II. Responses to Comments

A. Introduction

B. Topical Responses

1. Warner Center 2035 Specific Plan

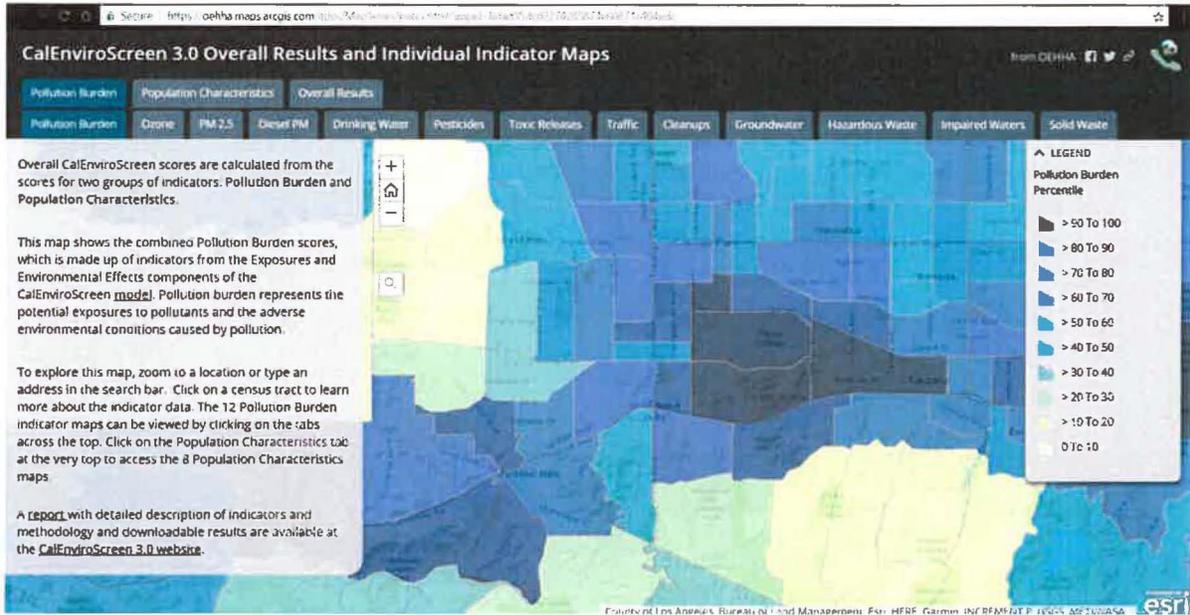
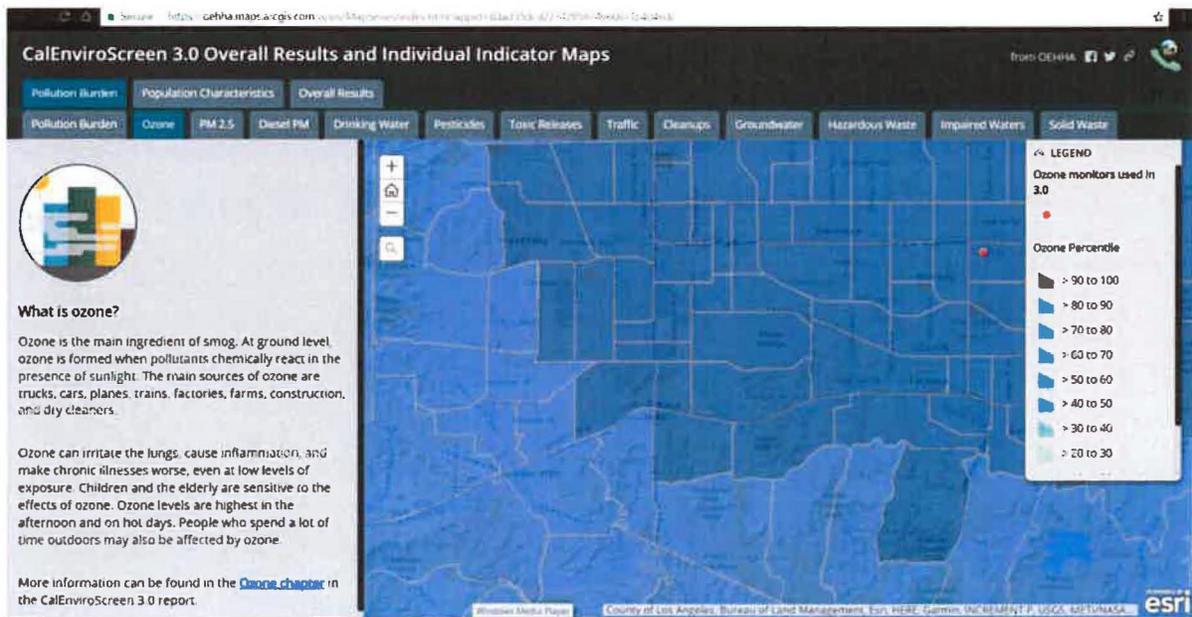
My very favorite maps are the individual tabs on the Pollution Burden maps:

So this screen shot is the Pollution Burden overall score today for this part of the West San Fernando Valley.

The information provided in the screenshots of the various CalEnviroScreen rankings do not change the significance conclusions in the Draft Supplemental EIR.

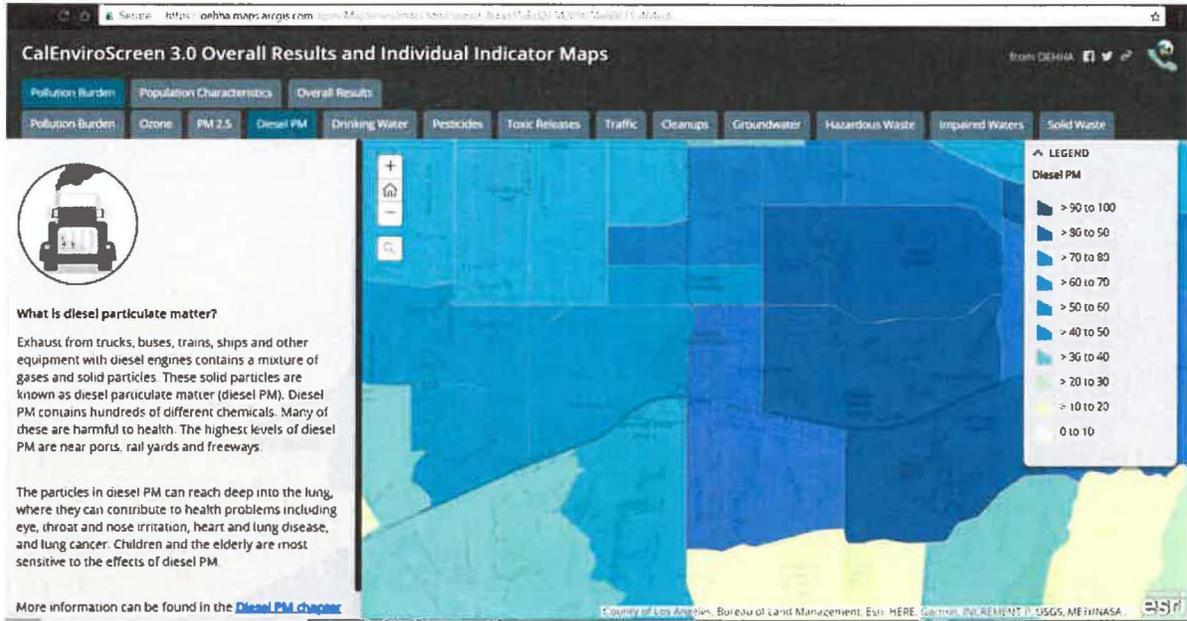
This map is for ozone in the West San Fernando Valley – this is what we are breathing now.

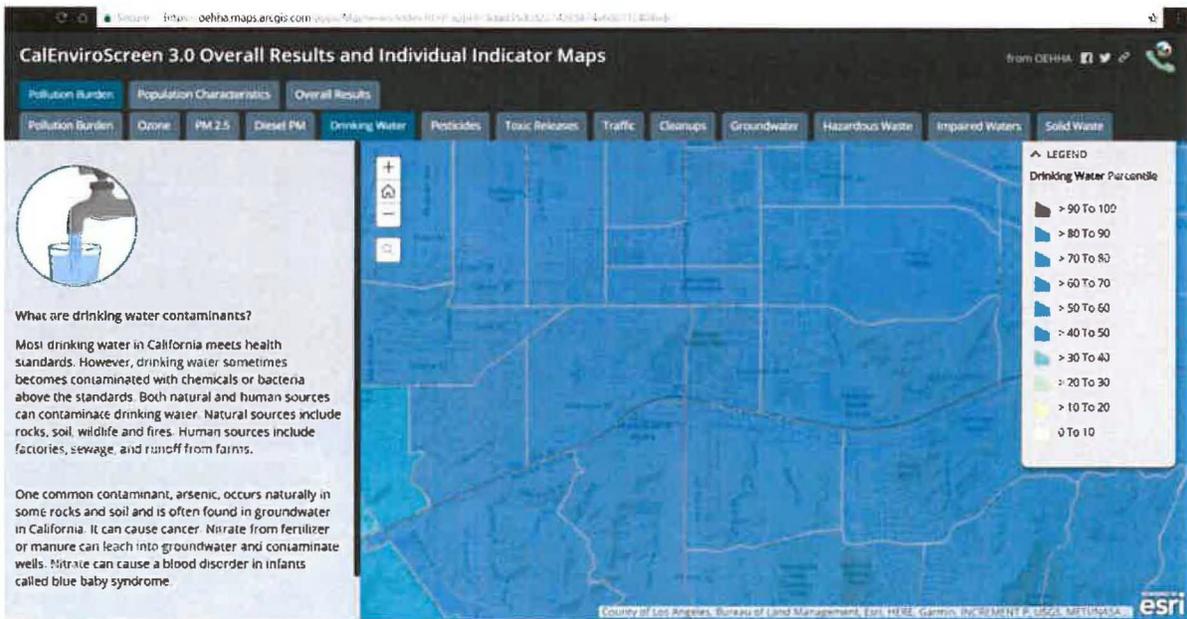
This map shows the existing impacts of Diesel emissions in the surrounding community – think future trucks for all of these projects.

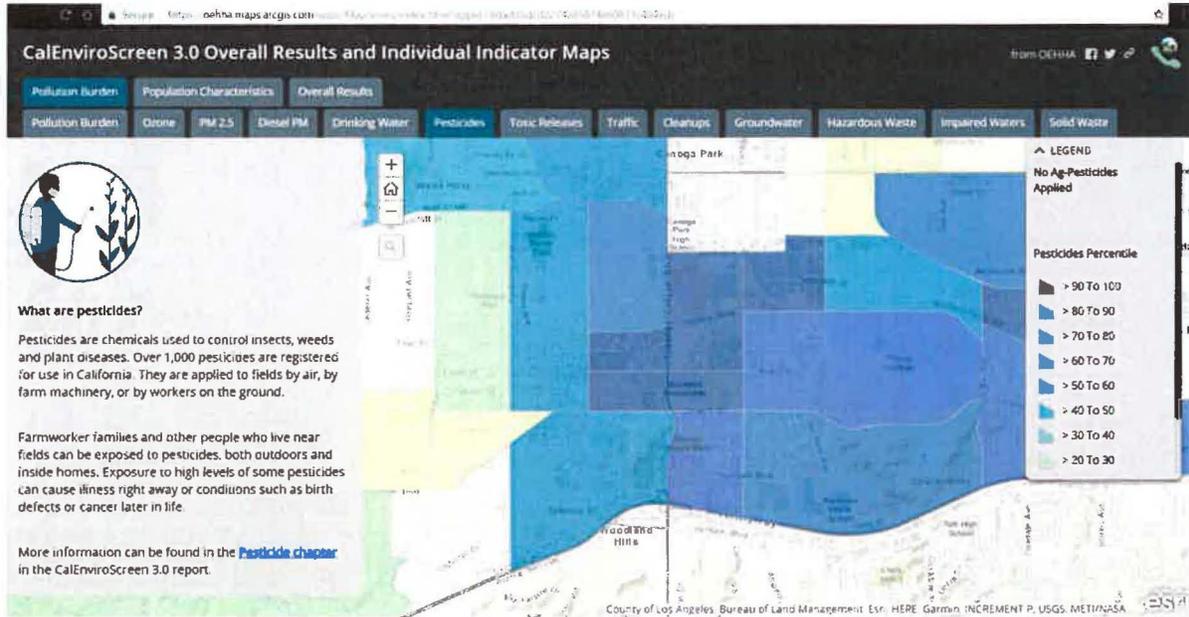
This screen shot shows the drinking water contamination in the Woodland Hills Warner Center area which includes the Promenade property.

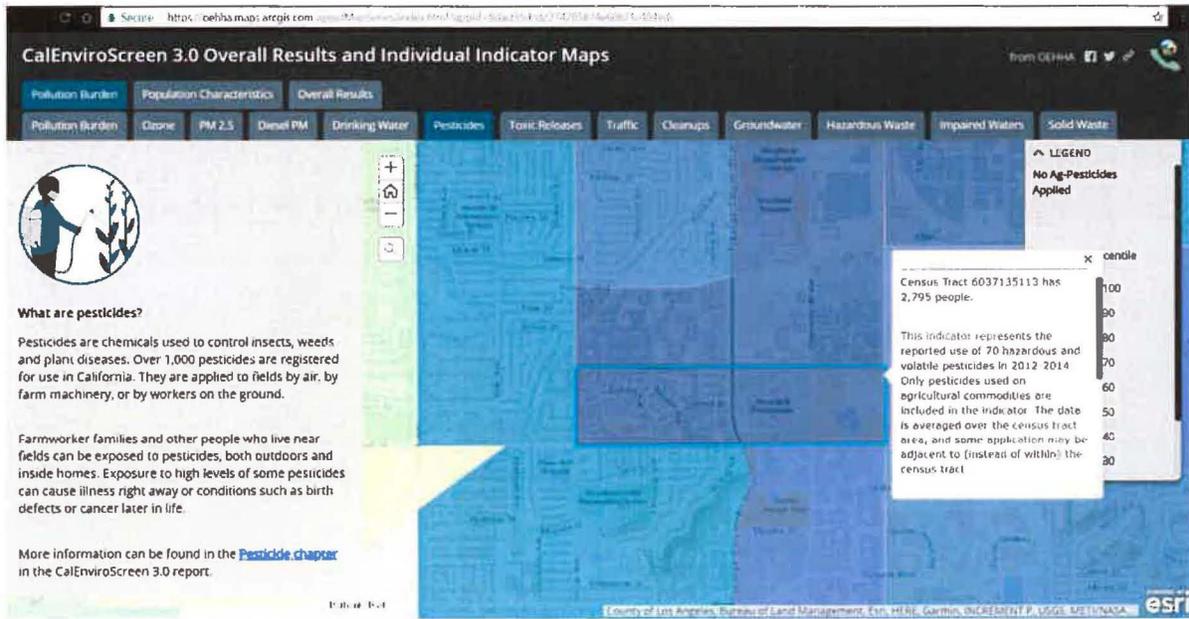
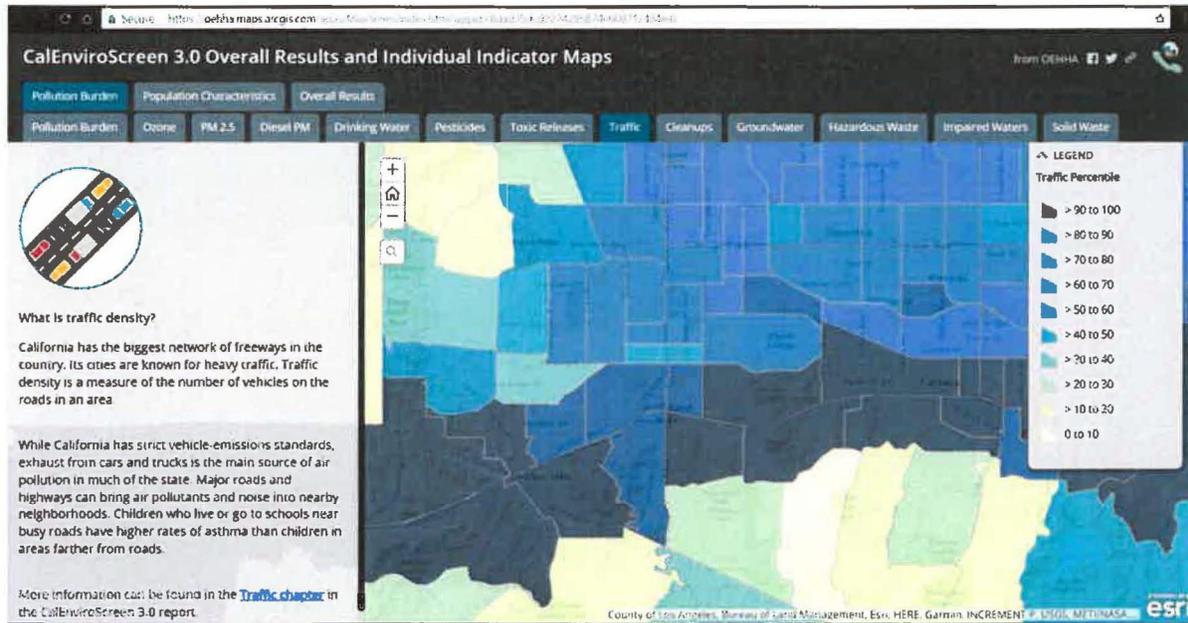
Very interesting to see the pesticide levels on the Promenade property.

So with this lovely view of the pesticides within the Promenade census tract, is this what the future residents and the future users of the proposed stadium and the open space will be breathing?

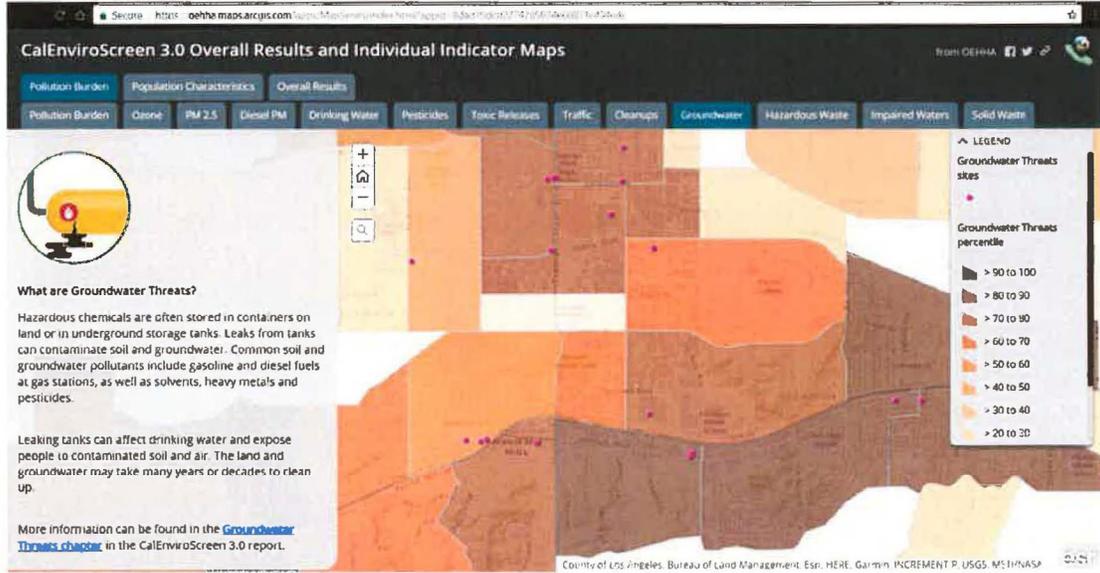
So this lovely map shows the existing traffic impacts along the 101 freeway and into our project area. How can we plan unsustainable project let alone a stadium with the current impact on our air quality from traffic?

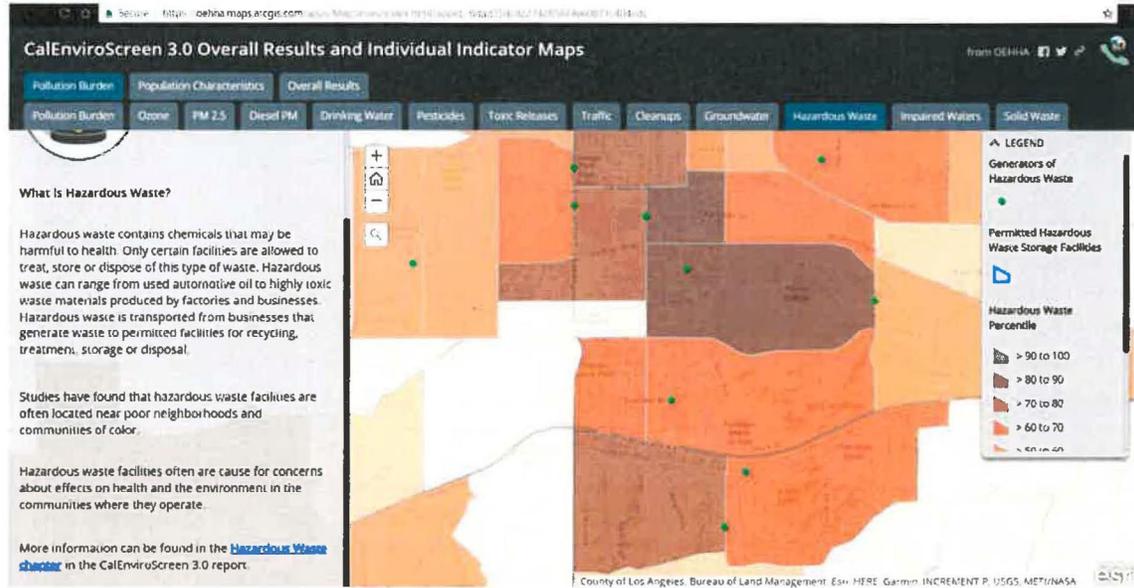
This is a map to show the Groundwater threats around the project site. So while the Promenade site does not appear to have any known sites, let's look at all of the groundwater contamination at Westfield's other two properties, the UTC Rocketdyne property, as well as the Adler property area.

Groundwater is shallow in some areas of Warner Center. I believe it is 15 to 20 feet below surface at UTC Rocketdyne. So how are any parking structures going to be built below grade with those ground water levels?

How are you going to prevent vapor intrusion into your residences and into your open space areas?

further in Section IV.E, Hazards and Hazardous Materials, of the Draft Supplemental EIR, groundwater samples were collected from three locations at the Project Site: the northwest corner, the northeast corner and the southern perimeter. Samples were analyzed for VOCs. No VOCs were detected in the soil samples. VOCs were not detected above screening levels in groundwater in the northern portion of the Project Site, but were detected above screening levels at one location in the southern perimeter. It is anticipated that the detected VOCs are migrating from off-site. However, the groundwater data was evaluated using Project Site specific geotechnical information and standard modeling tools, and it was concluded that the estimated potential for such contaminants to migrate into indoor air at the Project Site are below risk-based thresholds for both commercial and potential future residential scenarios. As discussed previously, construction activities for the Project would include excavating down a maximum of 75 feet for basement levels, buildings structures, and hardscape and landscape around structures. Therefore, there is the potential to encounter contamination in the subsurface during excavation activities for the subterranean parking garages at depths at or below the groundwater level. Construction activities would occur in accordance with applicable federal, state, and local regulations and requirements, including specific OSHA requirements regarding worker safety. With compliance with relevant regulations and requirements, Project construction activities would not expose people to a substantial risk resulting from the release or explosion of a hazardous material, or from exposure to a health hazard, in excess of regulatory standards. In the event that contaminated soils are encountered during excavation, based on visual, olfactory, or vapor reading detection, the nature and extent of the contamination shall be determined and appropriate handling, disposal and/or treatment shall be implemented in accordance with applicable regulatory requirements, such as SCAQMD Rule 1166, which provides requirements to control the emissions of VOCs. In the event contaminated soils are encountered, no contaminated soils would be stockpiled on the Project Site. Therefore, impacts related to the potential to encounter contamination in the subsurface during construction at the Project Site were found to be less than significant.

The information provided in the screenshots of the various CalEnviroScreen rankings do not change the significance conclusions in the Draft Supplemental EIR.

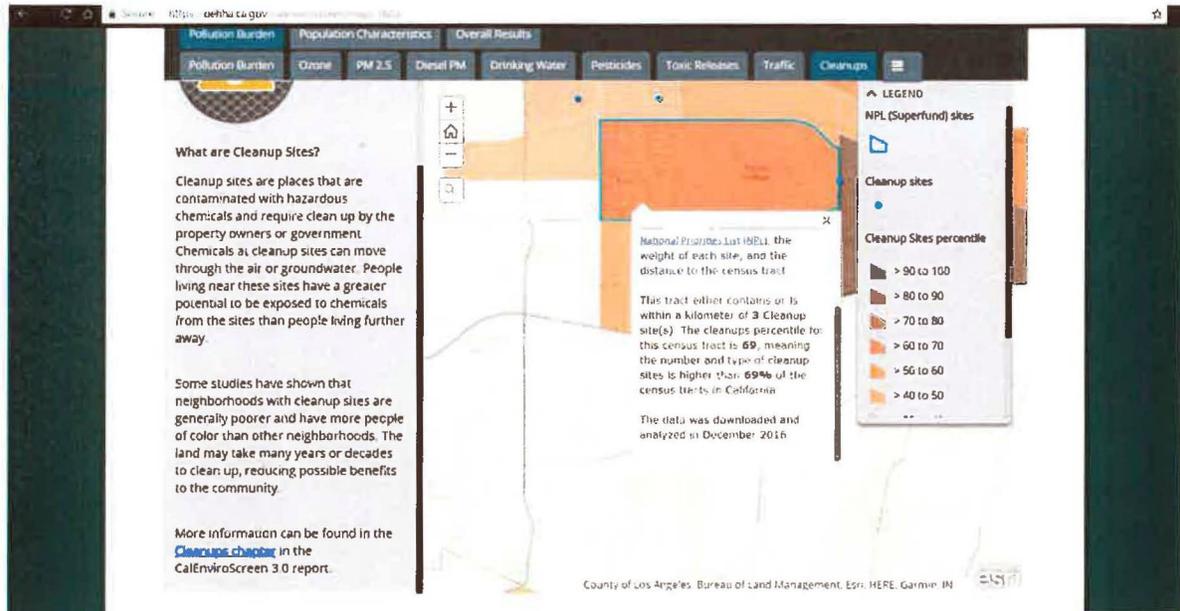
So while the Promenade may not have any cleanup sites on it, please see the adjacent census tract and its score as 69 – which means it is worse than 69% of the other census tracts in the State of California. How will the remediation of these sites impact the Promenade projects?
